July 7, 2020

Re: ZBA 20-12,13,14 Proposed Updates

A **PROPOSED SITE PLAN**
SCALE 1/16" = 1'-0"

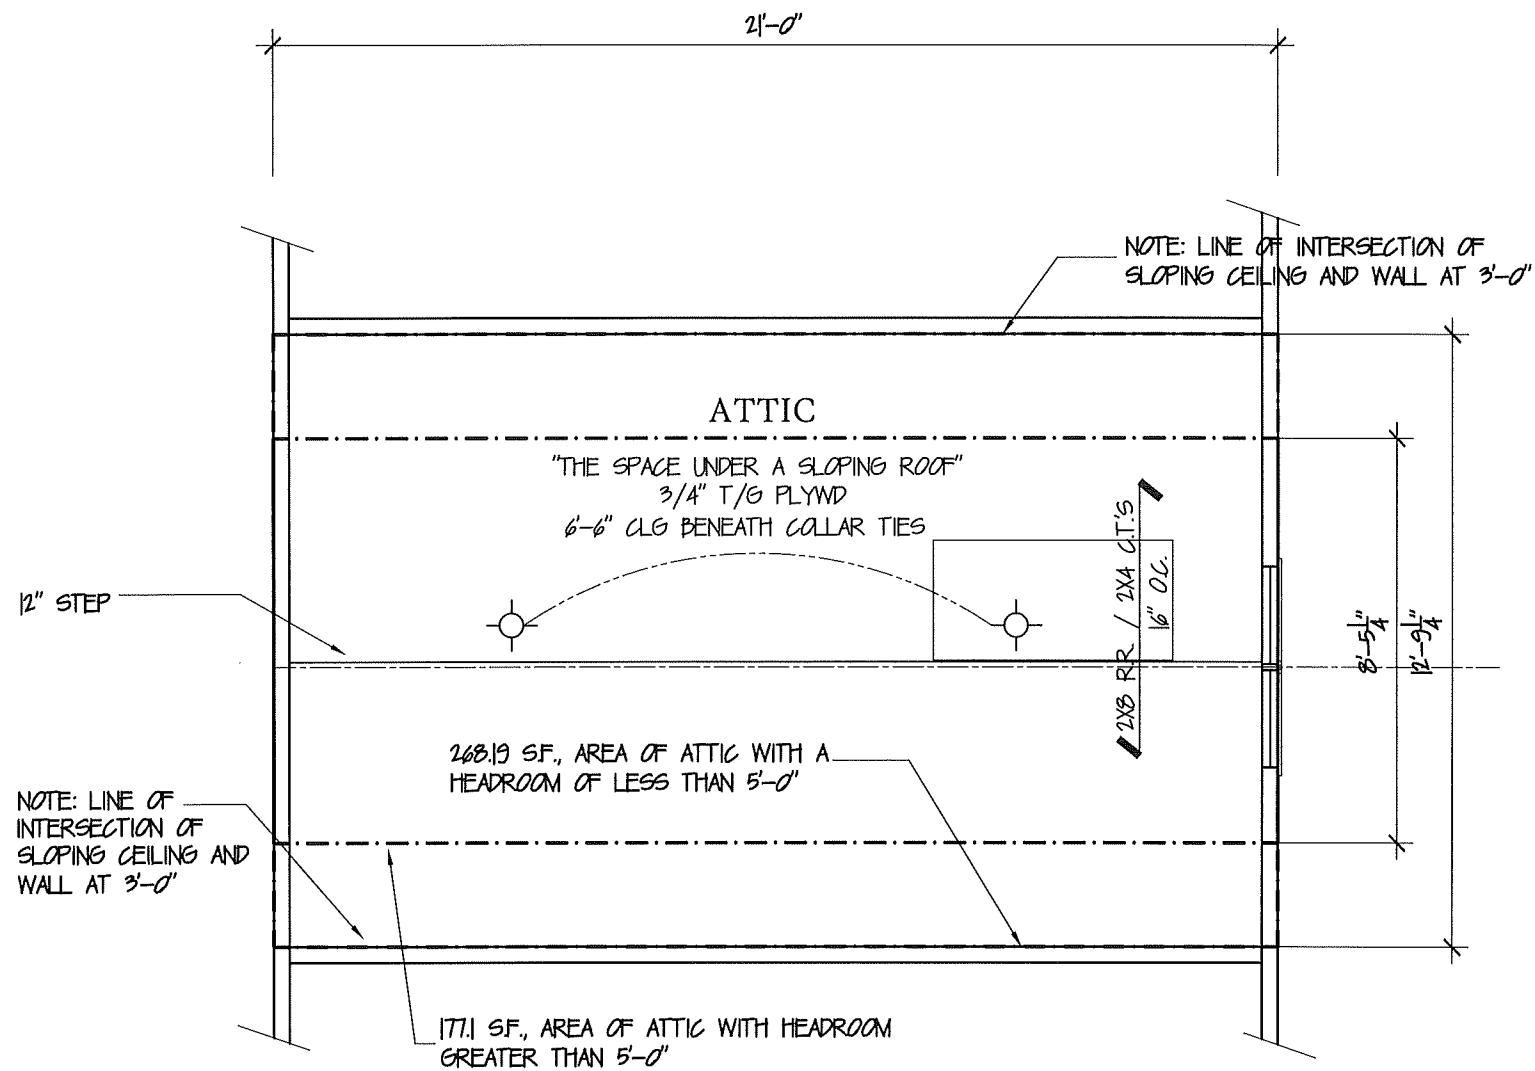
- Reduced the garage size to 20.5 deep by 21' wide. This will bring the building coverage to 34.98%, and therefore compliant, even with the undersized lot, eliminating the requirement of ZBA 20-13. The side and back lot variations ZBA 20-12(1 & 2) are still required and requested.

- The driveway and front walkway area are shown reworked to comply with the 9' minimum driveway width and accommodate the new garage entrance. The changes removed the connector path between the entrance walk. We adjusted the approach angle to the second garage to the minimum size we thought navigable. The net was a reduction of lot coverage from 49.96% (existing non-conforming – conforming during last permit) to 49.91%. This would still require the variance ZBA 20-14, which is requested.

B ATTIC PLAN
SCALE 1/4"=1'-0"

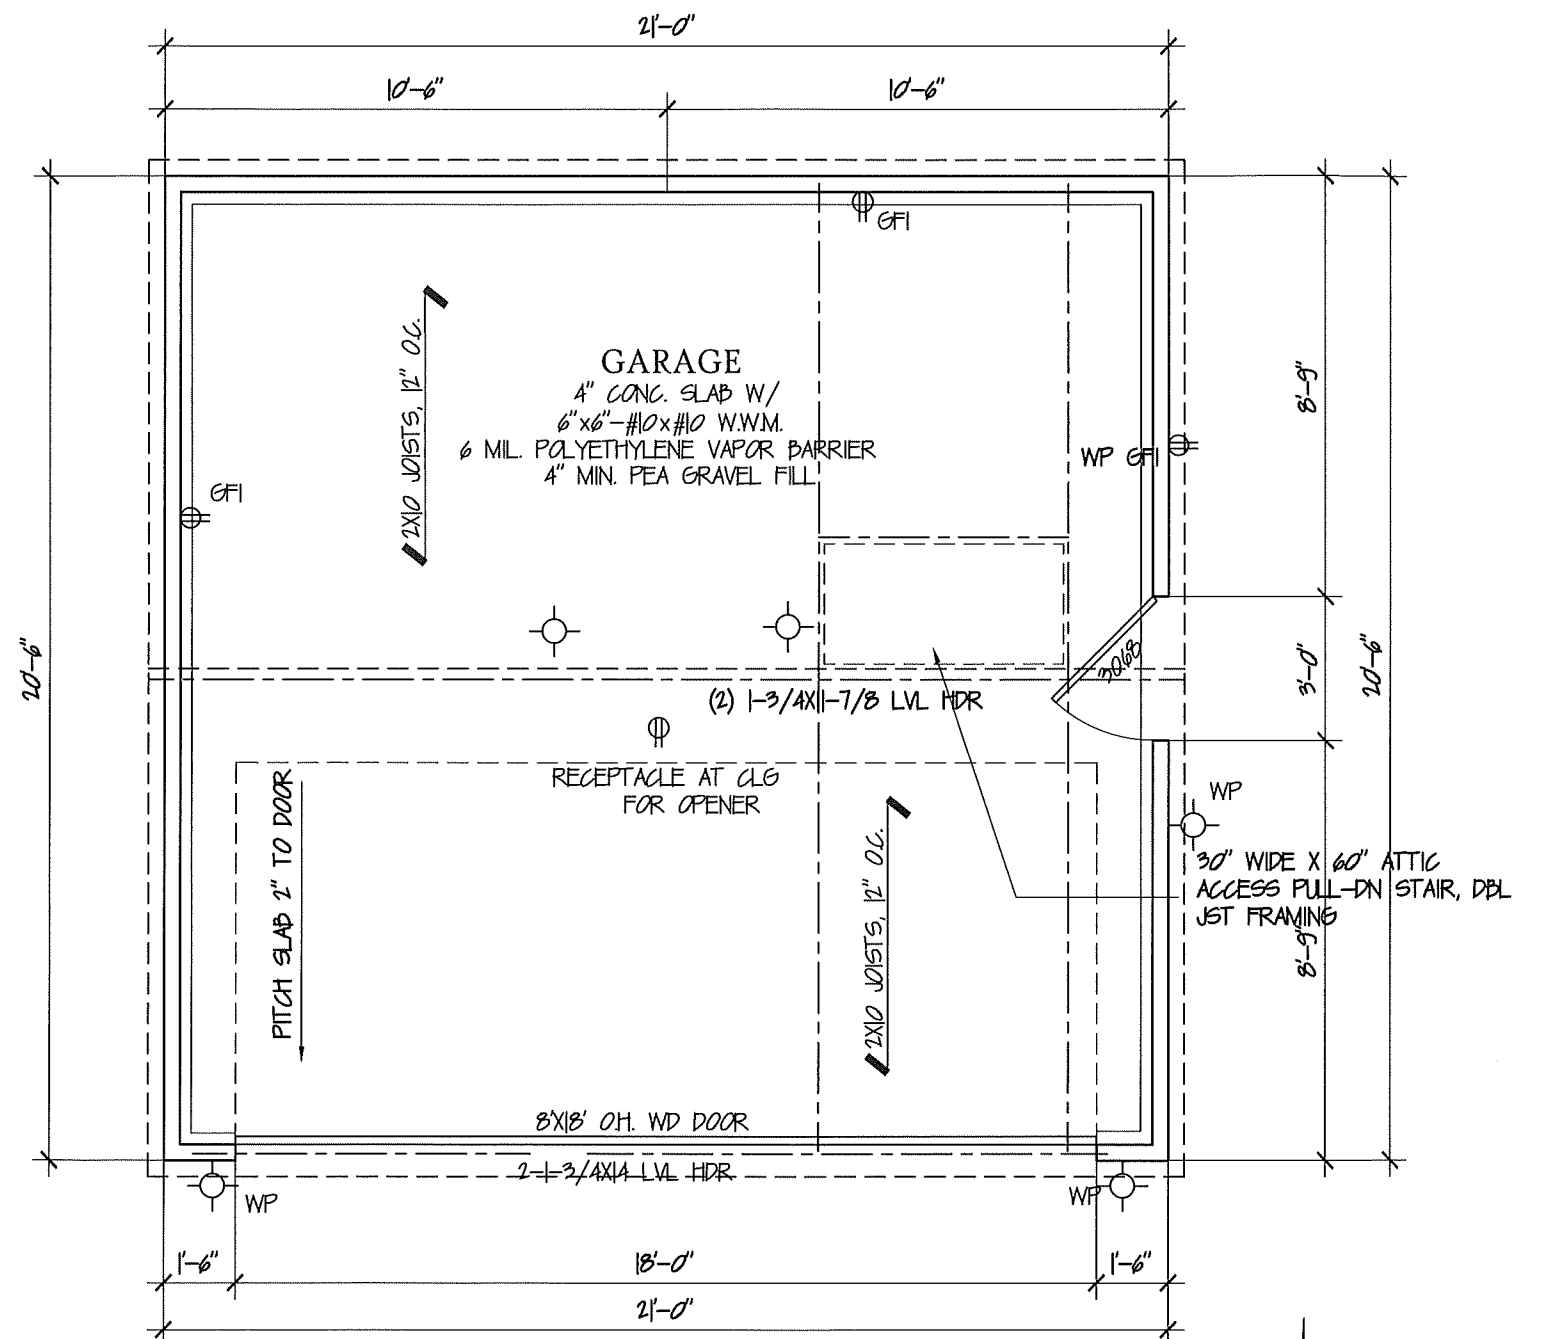
- The second story has been reworked to meet the village requirements of a half story, removing the rear shed dormer, and is now accessible by a pull-down stairway.

1/2 STORY:
CONDITION 1: SPACE UNDER A SLOPING ROOF THAT HAS THE LINE OF INTERSECTION OF THE WALL AND ROOF FACE NOT MORE THAN 3' ABOVE THE FLOOR LEVEL - COMPLIES

CONDITION 2: THE POSSIBLE FLOOR AREA WITH HEAD ROOM OF 5'-0" OR LESS OCCUPIES AT LEAST 40% OF THE TOTAL FLOOR AREA OF THE STORY DIRECTLY BENEATH:

177.1 SF. ACTUAL
40% OF THE FLOOR AREA BENEATH = (430.5 X 0.4) = 172.2 SF. - COMPLIES

THUS THE ATTIC IS CONSIDERED A 'HALF STORY'
